Planning & Zoning Board Meeting

ZONING MEMORANDUM

Meritage Homes- Elevation/ Architectural Plans Hillside Groves (The Reserve PUD) Applicant: Meritage Homes

Meritage Homes 4R15 (Formerly Foxglove)

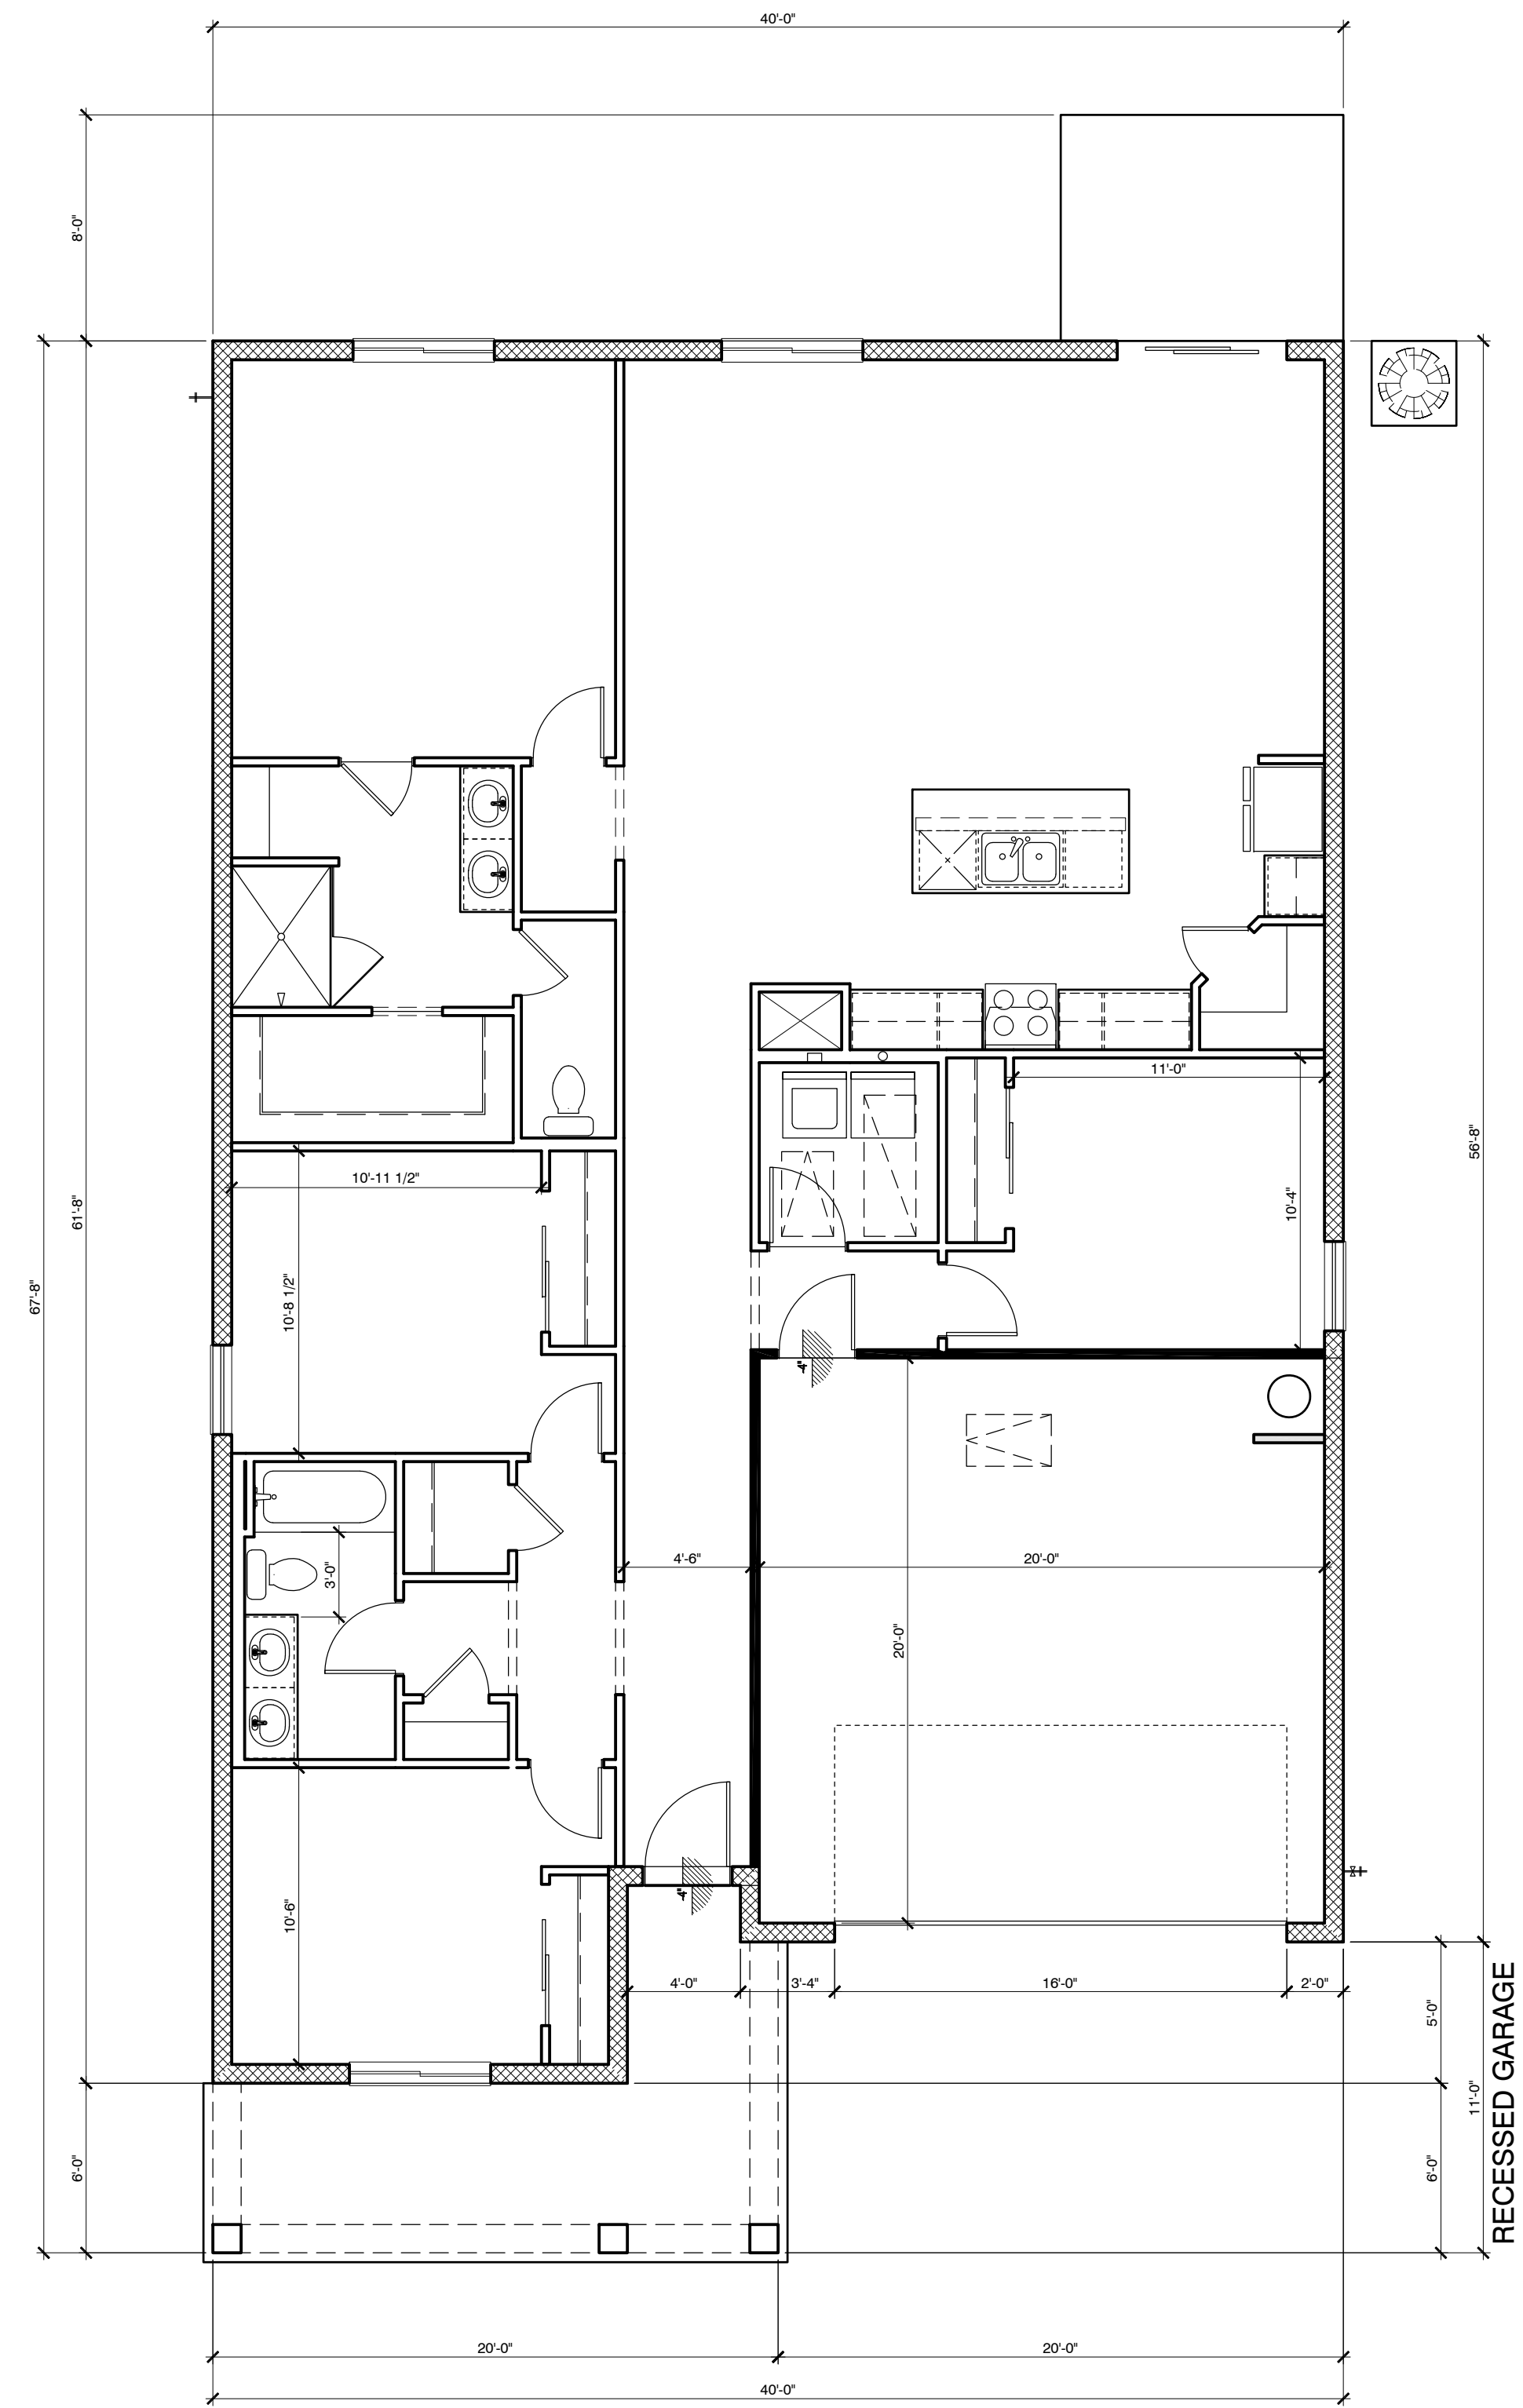
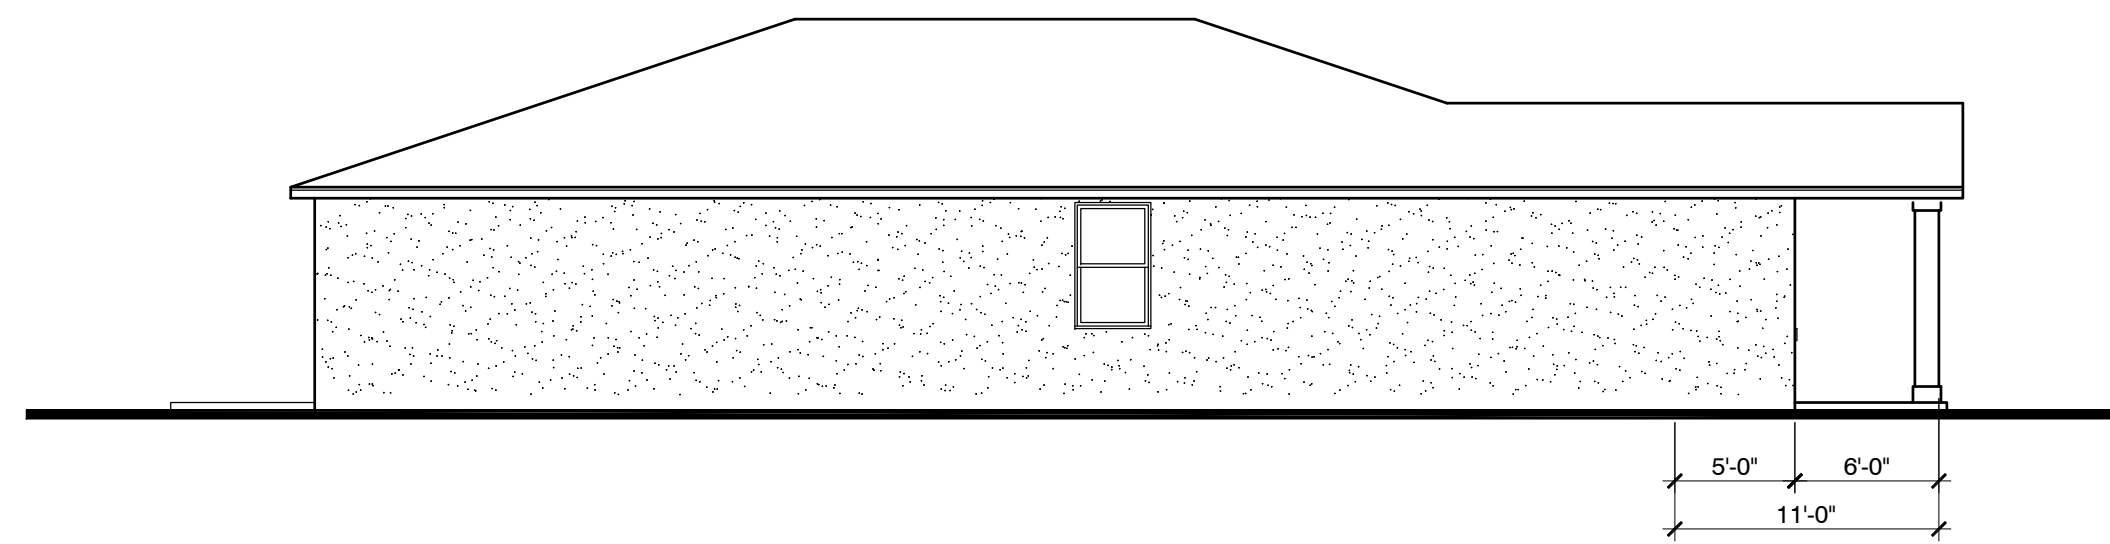
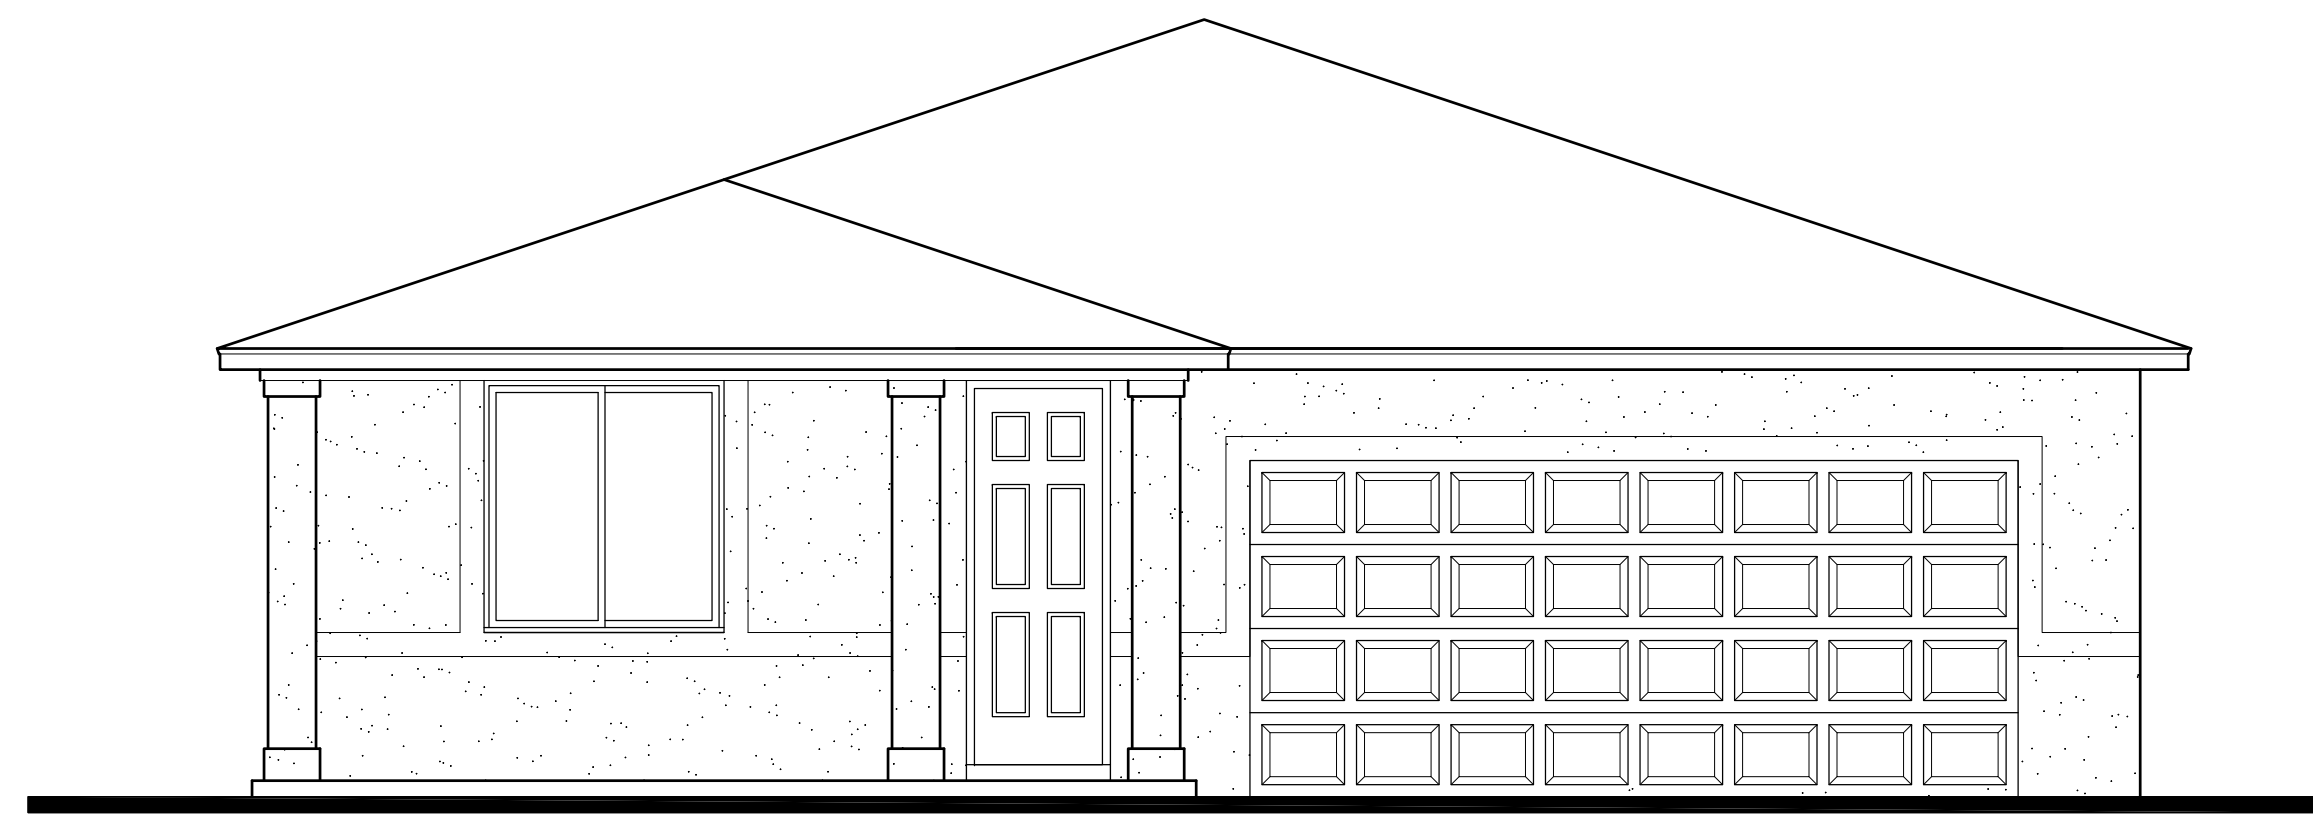
The proposed models appear to provide porches and recessed garages consistent with LDC Sec. 4.06.02 (A) (2) and (3). Additional detail on the porches would be helpful though to determine if they are at or above grade or have articulation designating them as usable front porches. As an example, none of the porches show railings as part of the design.

The proposed elevations show what appears to be stonework and varying materials on the models, however no product types, colors or materials are identified on the plans. The elevation plans need to be revised to demonstrate and specify materials to ensure that they are consistent with the following LDC Sections which state:

The proposed elevations do not identify the roof materials to be used nor detail on eave design. The plans need to be revised to demonstrate and specify roof materials and eaves detail to ensure that they are consistent with the following LDC Sections:

The application provides some of these details but not all that are required for each of the facades. Consistent with LDC Sec. 4.06.03, the plans need to be revised to show and label the front, side, and rear facade elevations for each model and identify the specific architectural details on each façade, demonstrating how they are consistent with the type and quantity required in LDC Sec. 4.06.03 (C).

Recommendation: The model elevations should be revised consistent with the requirements identified in the review comments below and be brought back to the Planning and Zoning Board for consideration.
